**Re: Compark Village South Multifamily – Variance Request – Storm Drainage Criteria**

RE: **SUB21-065 // Minimum Standards Variance Request  
Hydraulic Grade Line Design Requirement**

**COMPARK VILLAGE SOUTH  
PRIVATE IMPROVEMENT  
CONSTRUCTION PLANS**

**EXHIBIT A**

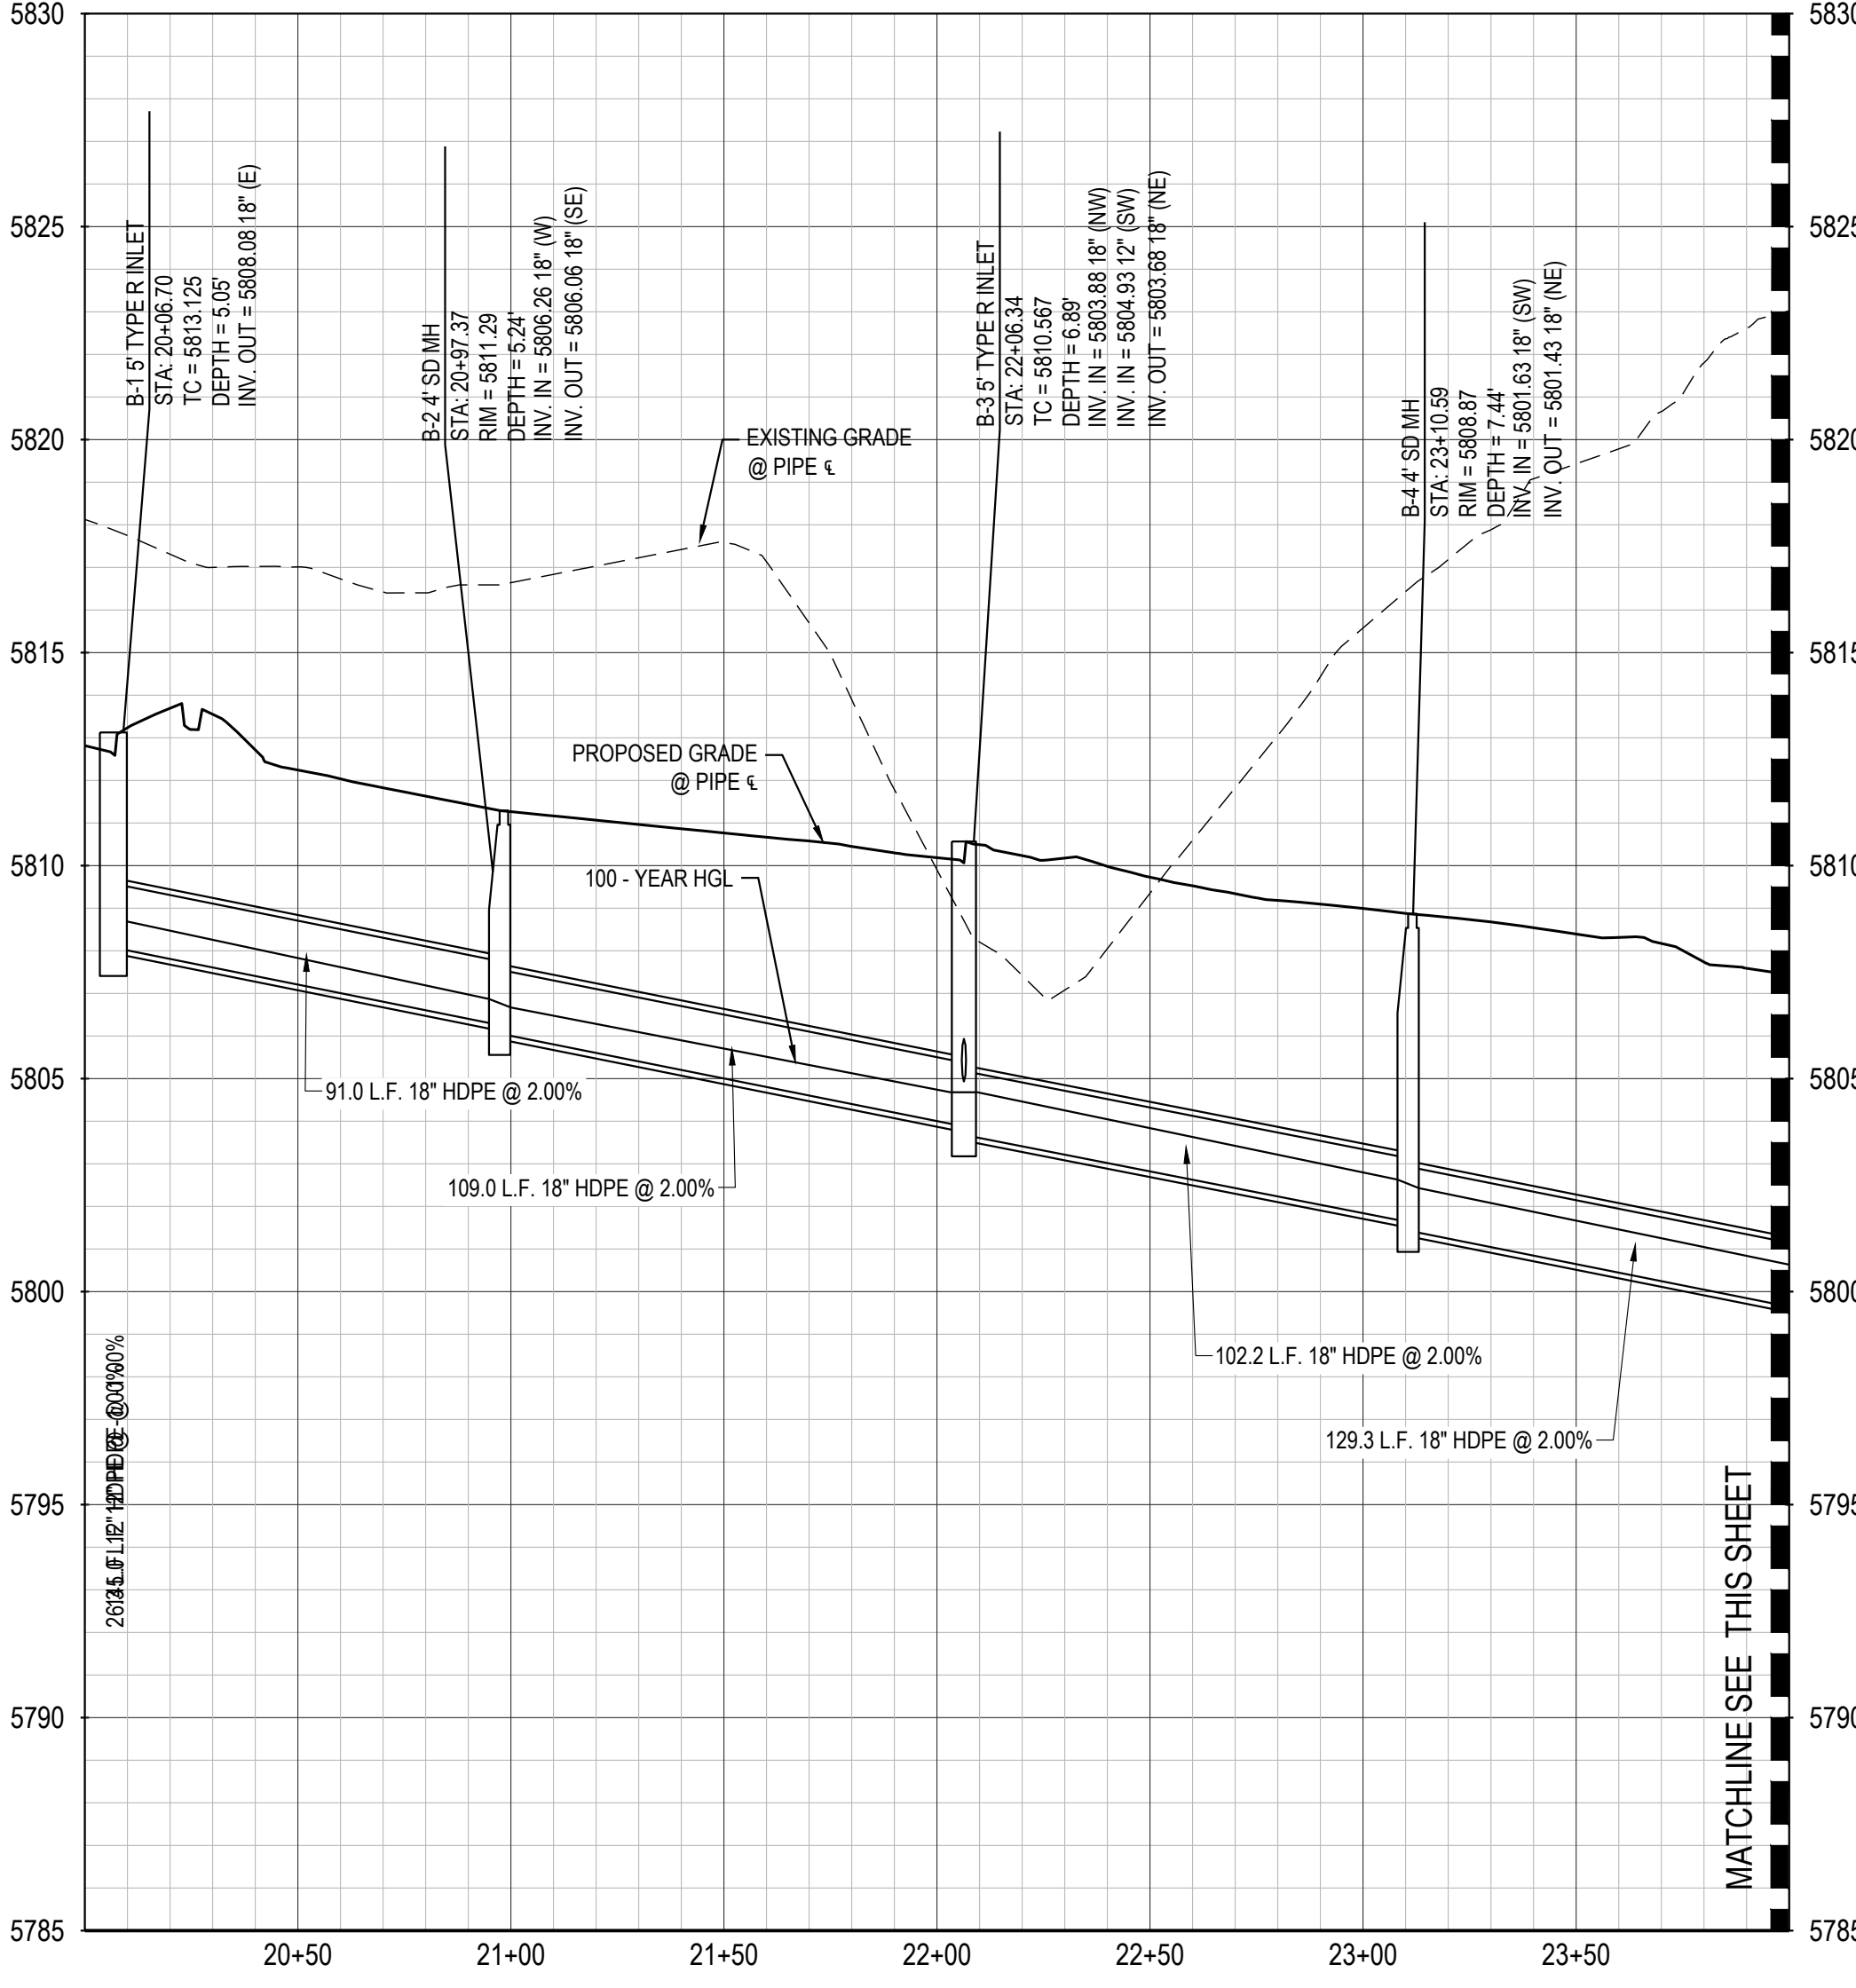
During the initial review of the Public Improvement Construction Plans for this site, the Town commented that the proposed storm sewer would need to be within a 25-ft storm sewer easement, and that proposed retaining walls (and any required structural reinforcing) could not be within that said storm easement (Refer to Exhibit A). As such, the proposed storm sewer system for the multi-family development was re-aligned such that the retaining walls would not be within the easement (Refer to Exhibit B), but in doing so, a section of the storm sewer system now fails to meet the requirements of Section 6.3.3.4 of the Towns SDECM.

1. Application SUB21-065 is still active and has not been before City Council for approval and plan check comments from Town staff are still be addressed.
2. By allowing the design as shown on Exhibit B, we believe the design as shown creates a safe and quality design. If the maintenance path were to be raised to meet the requirements of Section 6.3.3.4 of the SDECM, a retaining wall approximately 4-ft tall would be needed on the downhill side of the path, presenting a potential hazard for larger maintenance vehicles and/or trailers.

The storm sewer system was designed based on the major storm HGL having a starting tailwater elevation equal to the 100-year storm event pond water surface elevation. Should a surcharge of the system occur at manhole B-10, the plans call for a bolt down lid, and should that lid fail, it would not pose a safety risk to any structure or property given the proximity to the adjacent Flood Hazard Area Delineation.

The storm sewer structure and pipe which do not meet the Town’s criteria for HGL in the major storm should not present in any undue safety concerns. Should the storm system fail in a major storm event, no structures or public facilities would be threatened by flows, which would be conveyed to Happy Canyon Creek. Additionally, raising the elevation of the pond access road in order to meet the HGL criteria would result in a steep drop-off requiring retaining walls, which would create an undesirable condition for maintenance vehicles using this access.
